## FS162-06/07

### 803.9.1 (New), Table 803.9.1 (New)

**Proponent:** Marcelo M. Hirschler, GBH International, representing American Fire Safety Council

**FIGURE 1611.1 IPC 1106.4  
100-YEAR, 1-HOUR RAINFALL (INCHES) EASTERN UNITED STATES**

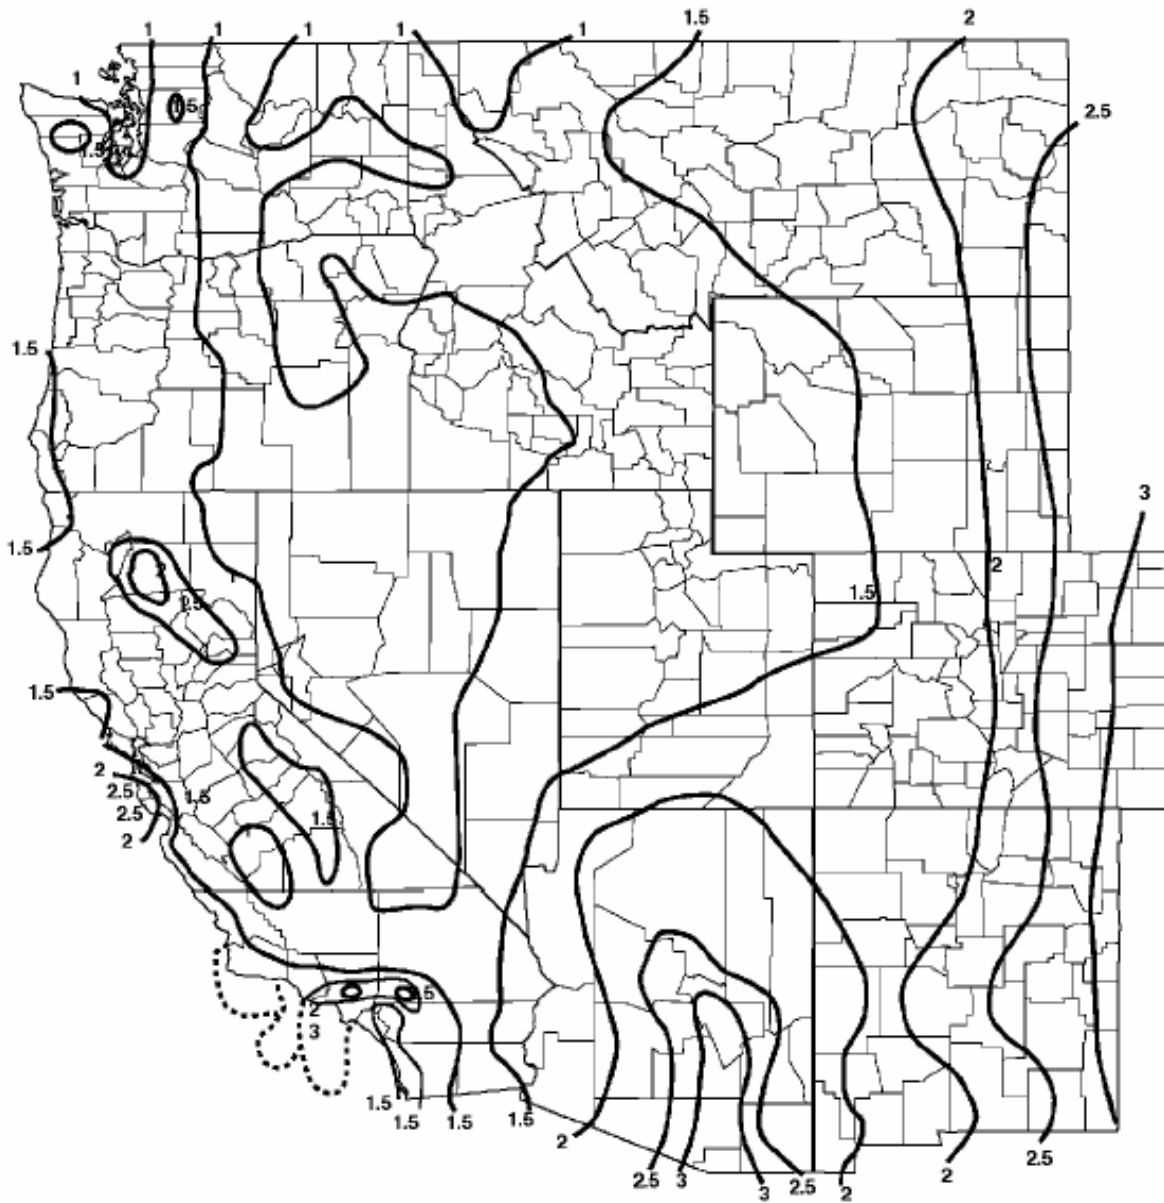
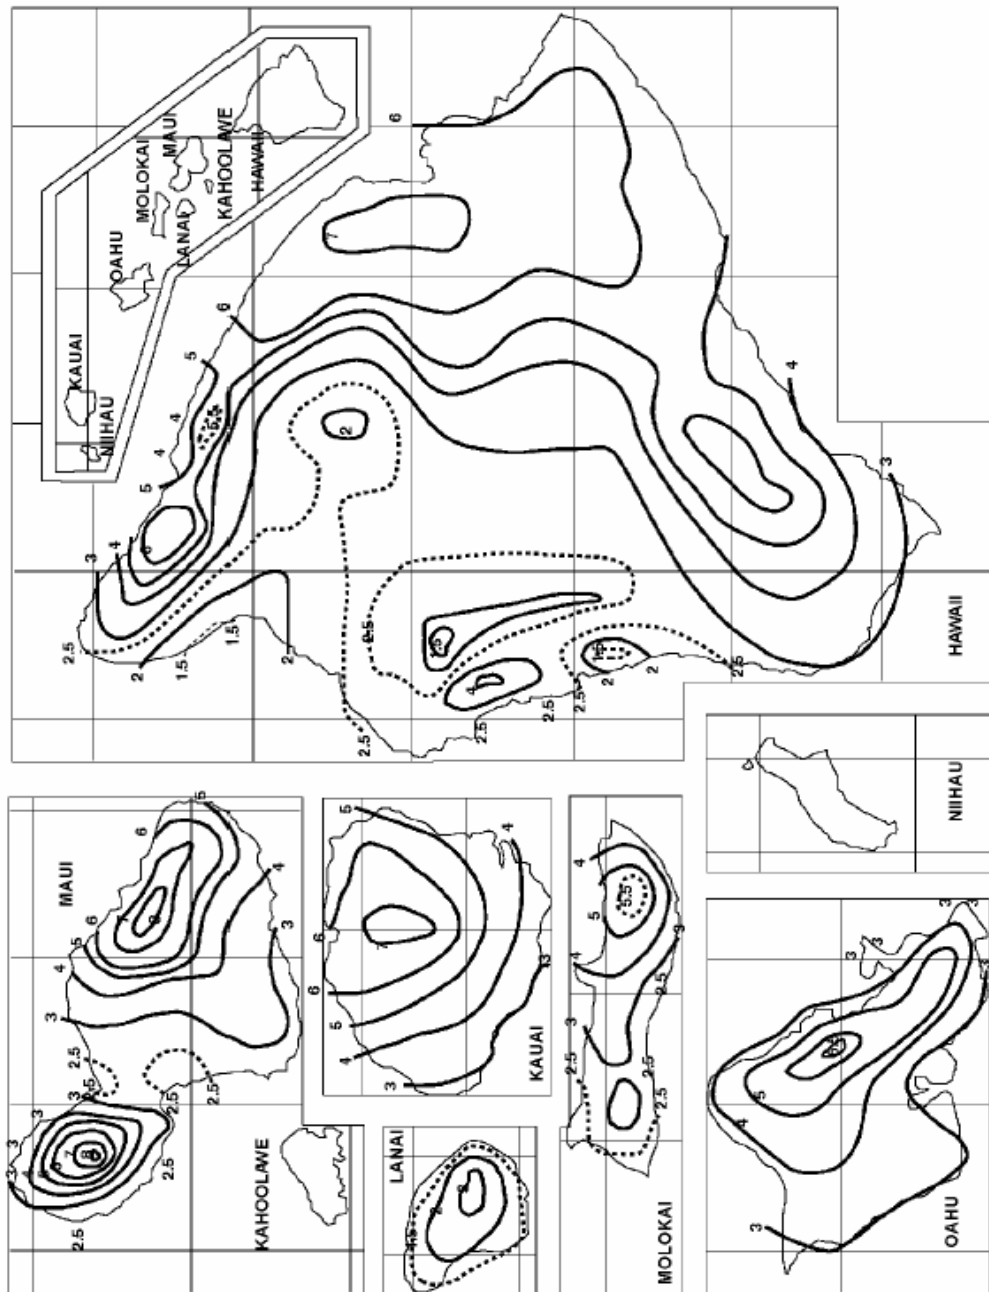
### **3. Insert figure as shown:**

**Insert all of IPC Figure 1106.1 and renumber as shown**

**1611.1 Design rain loads.** Each portion of a roof shall be designed to sustain the load of rainwater that will accumulate on it if the primary drainage system for that portion is blocked plus the uniform load caused by water that rises above the inlet of the secondary drainage system at its design flow. The design rainfall shall be based on the 100-year hourly rainfall rate indicated in Figure 1611.1 or on other rainfall rates determined from approved local weather data.
